ARKANSAS POWER & LIGHT COMPANY
POST OFFICE BOX 551 LITTLE ROCK, ARKANSAS 72203 (501) 371-4000

1CAN118203

SUBJECT: Arkansas Nuclear One - Unit 1
Docket No. 50-313
License No. DPR-51
Inservice Inspection (ISI)
Relief Requests

Figure 1 to
1CAN118203

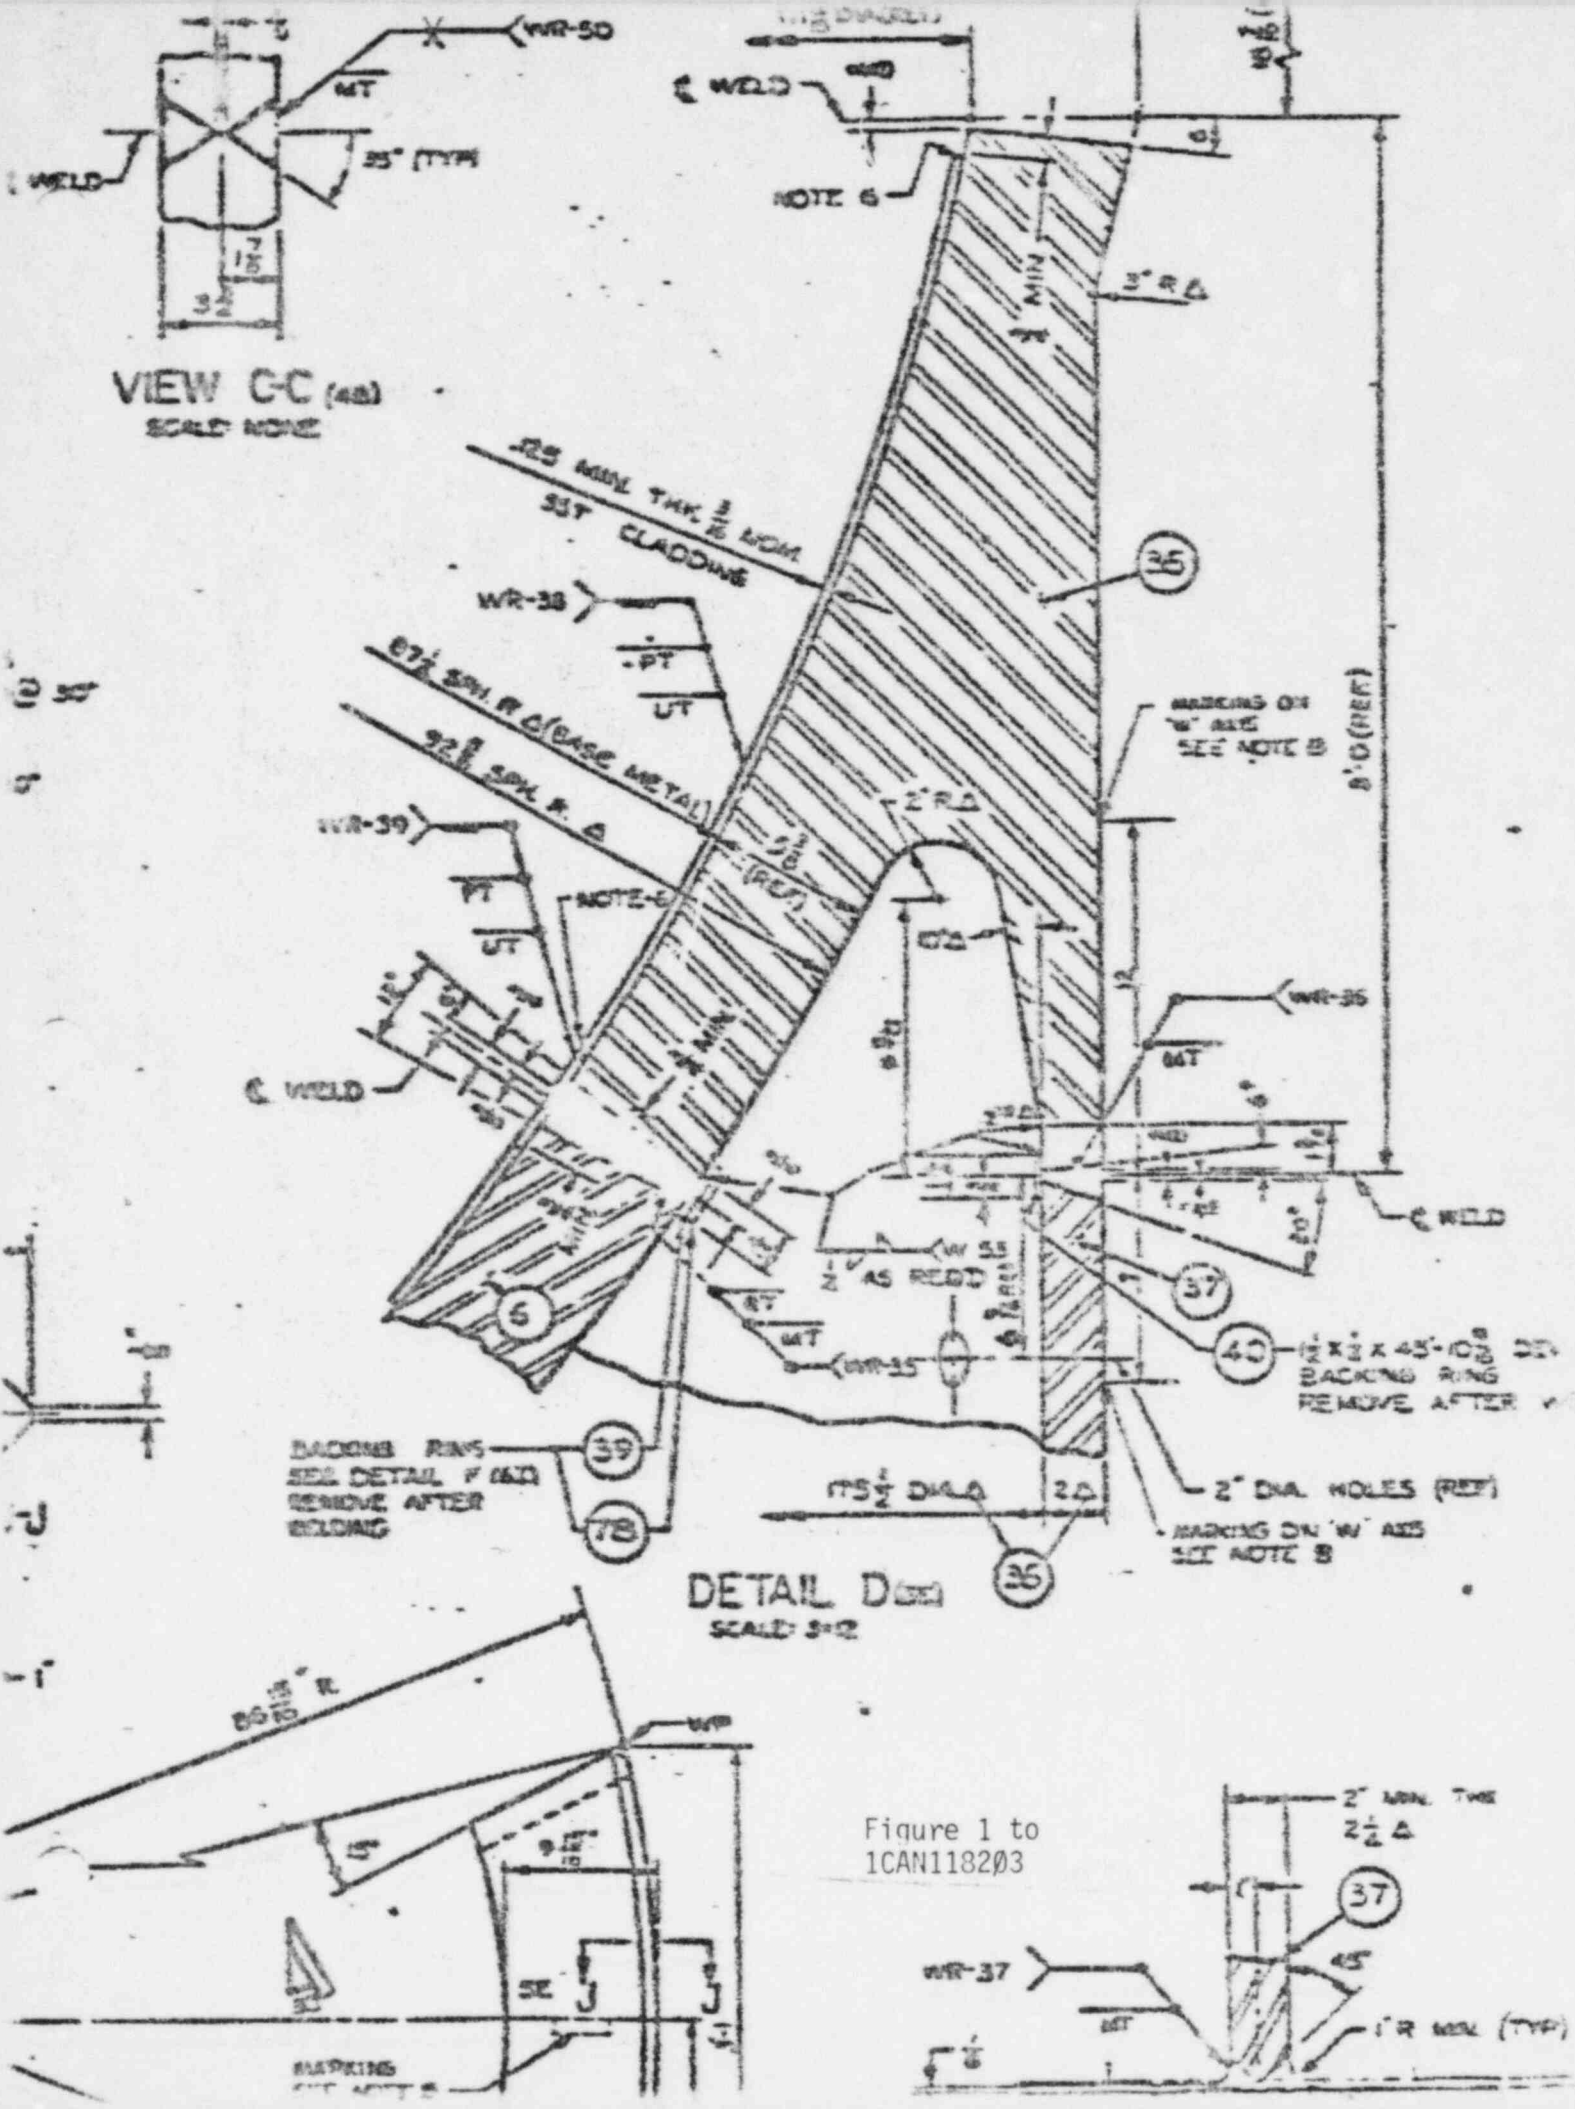
- (2) AP&L requests relief from the requirement to do a volumetric examination of the reactor vessel support skirt weld as required by the 1974 Edition of Section XI (Item B1.12, Examination Category B-H).

Basis - The reactor vessel support skirt-to-vessel weld is impractical to examine volumetrically considering access for examination equipment, the necessity of insulation removal, personnel exposure to a 150-200 mR general area radiation field in the range of 1R on contact with insulation, and the amount of time required to obtain acceptable results. With insulation removed, close proximity radiation readings are expected to be considerably higher. This weld is not considered part of the Section XI, Class 1 (IWB) boundary under the rules of the 1980 Edition and therefore would be exempt from any examination requirements (See Figures 1 & 2).

Proposed Alternate Examination - None.
